UNITED STATES PATENT AND TRADEMARK OFFICE

APPLICATION NO.	FILING DATE	FIRST NAMED INVENTOR	ATTORNEY DOCKET NO.	CONFIRMATION NO.
09/506,870	02/15/2000	Charles S. Vann	0550-0076.30	6464

Office Action Summary	Application No.		Applicant(s)	
	09/506,870		VANN ET AL.	
	Examiner		Art Unit	
		P. Kathryn Bex	1743

DETAILED ACTION

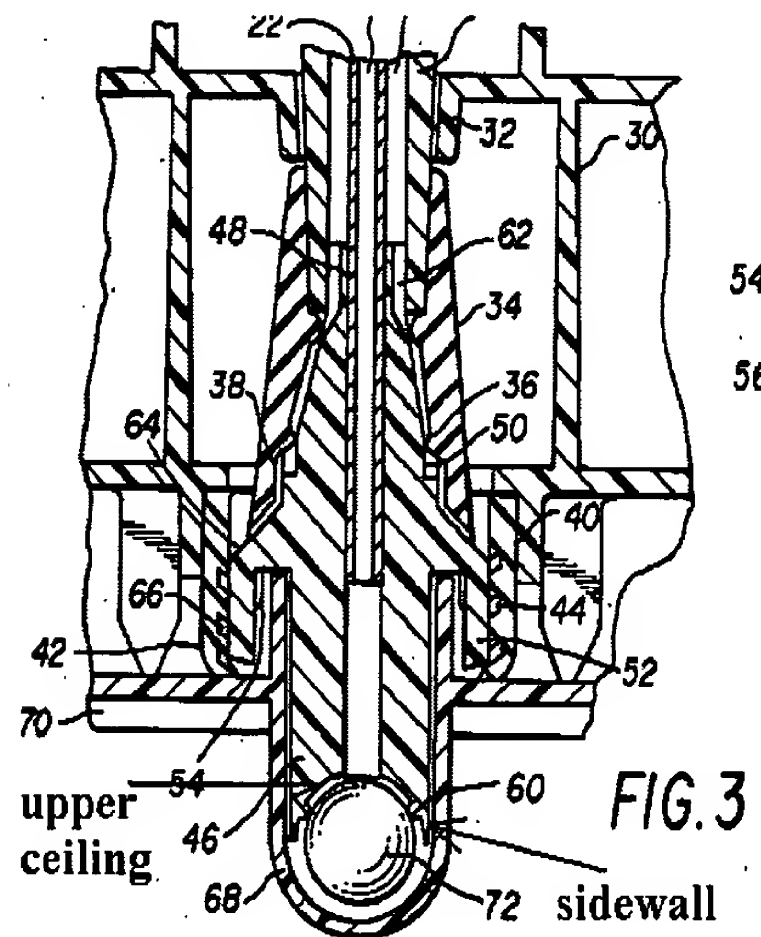
4. Claims 1, 3, 6-7, ~~14-17~~¹⁵ are rejected under 35 U.S.C. 102(b) as being anticipated by Eck (USP 4,685,480).
loops

Eck teaches a combined washer and aspirator with a plurality of projections ²²48 depending from a support 30 at spaced-apart location defining a linear array and attached to a vacuum source via opening 14, effective to draw beads from containers 68. The projections having a

cavity formed at a lower end, each of the cavities defined by a lower opening, an upper ceiling region and a sidewall extending downwardly between the lower opening and upper ceiling region, wherein the upper ceiling region extends inwardly from the sidewall. Examiner has modified Figure 3 of Eck to clearly indicate the inwardly sloped upper ceiling region and downwardly extending sidewall (see Figure below).
